UNITED STATES PATENT AND TRADEMARK OFFICE

Office Action Summary	Application No. 10/586,538	Applicant(s) ADACHI ET AL.	
	Examiner NIKOLAY YUSHIN	Art Unit 2893

DETAILED ACTION

Drawing 4 of Masayaki

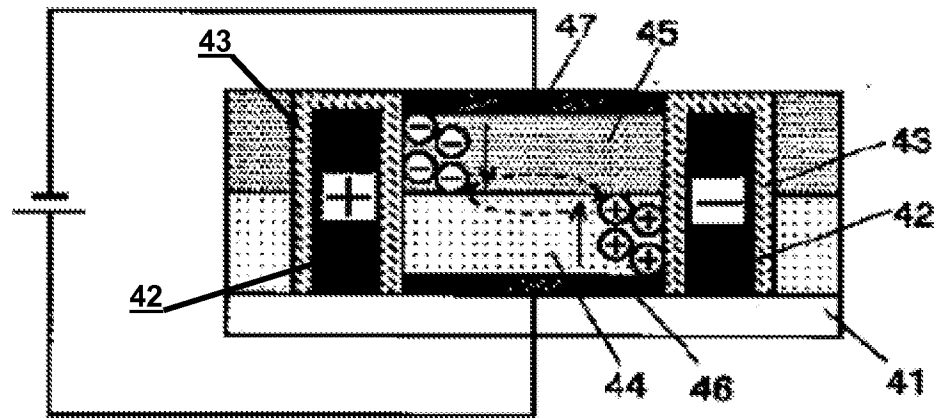
In re Claim 1, Masayaki discloses a organic semiconductor device (Fig. A below)), comprising: a bipolar organic semiconductor layer (44, 45) in which electrons and holes are movable; a hole giving/receiving electrode 46 for giving/receiving holes (shown by +) to/from the organic semiconductor layer (44, 45); an electron giving/receiving electrode 47, spaced a predetermined distance from the hole giving/receiving electrode 46, for giving/receiving electrons (shown by -) to/from the organic semiconductor layer (44, 45); a hole-side gate electrode (42, right), arranged opposing to a region of the organic semiconductor layer (44, 45) near the hole giving/receiving electrode 46 with an insulating layer 43 sandwiched, for controlling distribution of holes (shown by +) in the organic semiconductor layer (44, 45); and an electron-side gate electrode (42, left), arranged opposing to a region of the organic semiconductor layer (44, 45) near the electron giving/receiving electrode 47) with an insulating layer (43, left) sandwiched, for controlling distribution of electrons (shown by -) in the organic semiconductor layer (44, 45) (Fig. A; [0021 – 0023]).

In re Claim 2, Masayaki discloses that the organic semiconductor layer (44, 45) is formed of a bipolar organic semiconductor material (Drawing 4; [0023]).

In re Claim 3, Masayaki discloses that the organic semiconductor layer (44, 45) includes a laminated structural film with an N-type organic semiconductor layer 44 and a P-type organic semiconductor layer 45 laminated with each other (Drawing 4; [0023]).

In re Claim 4, Masayaki discloses that the organic semiconductor layer (44, 45) has a junction film structure including an N-type organic semiconductor layer 44 and a P-type organic semiconductor layer 45 having a junction portion between the hole giving/receiving electrode 46 layer and the electron giving/receiving electrode layer 47 (Drawing 4; [0021- 0023]).

In re Claim 6, Masayaki discloses that the hole giving/receiving electrode 46 is an hole injecting electrode for injecting holes (shown by +) into the organic semiconductor layer (44, 45), and the electron giving/receiving electrode 47 is an electron injecting electrode for injecting electrons (shown by -) into the organic semiconductor layer (44, 45) (Drawing 4; [0021 -0023]).

In re Claim 7, Masayaki discloses that the organic semiconductor layer (44, 45) is an organic semiconductor light emitting layer that emits light by recombination of holes (shown by +) and electrons (shown by -) in the layer (44, 45) (Drawing 4; Abstract, claim 3, [0019]).

In re Claim 8, Masayaki discloses that a control circuit that independently applies control voltages to the hole-side gate electrode (42, right) and the electron-side gate electrode (42, left) (Drawings 4 and 10; [0019]).

In re Claim 12, Masayaki discloses that the hole giving/receiving electrode 46 is an hole injecting electrode for injecting holes (shown by +) into the organic semiconductor layer (44, 45), and the electron giving/receiving electrode 47 is an electron injecting electrode for injecting electrons (shown by -) into the organic semiconductor layer (44, 45) (Drawing 4, [0022]).

In re Claim 13, Masayaki discloses that the hole giving/receiving electrode 48 is an hole injecting electrode for injecting holes (shown by +) into the organic semiconductor layer (44, 45), and the electron giving/receiving electrode 47 is an electron injecting electrode for injecting electrons (shown by -) into the organic semiconductor layer (44, 45) (Drawing 4; [0022]).

In re Claim 14, Masayaki discloses that the hole giving/receiving electrode 48 is an hole injecting electrode for injecting holes (shown by +) into the organic semiconductor layer (44, 45), and the electron giving/receiving electrode 47 is an electron injecting electrode for injecting electrons (shown by -) into the organic semiconductor layer (44, 45) (Drawing 4; [0022]).

In re Claim 15, Masayaki discloses that the hole giving/receiving electrode 48 is an hole injecting electrode for injecting holes (shown by +) into the organic semiconductor layer (44, 45), and the electron giving/receiving electrode 47 is an electron injecting electrode for injecting electrons (shown by -) into the organic semiconductor layer (44, 45) (Drawing 4; [0022]).

In re Claim 16, Masayaki discloses that a control circuit that independently applies control voltages to the hole-side gate electrode (42, right) and the electron-side gate electrode (42, left) (Drawings 4 and 10; [0019]).

In re Claim 9, Masayaki discloses all limitations of claim 9 including that the semiconductor device arranged on a substrate 41 (Drawing 4). However, Masayaki does not disclose a plurality of devices.

In re Claim 17, Masayaki discloses all limitations of claim 17 including that the semiconductor device arranged on a substrate 41 (Drawing 4). However, Masayaki does not disclose a plurality of the devices.

In re Claim 18, Masayaki discloses all limitations of claim 17 including that the semiconductor device arranged on a substrate 41 (Drawing 4). However, Masayaki does not disclose a plurality of the devices.
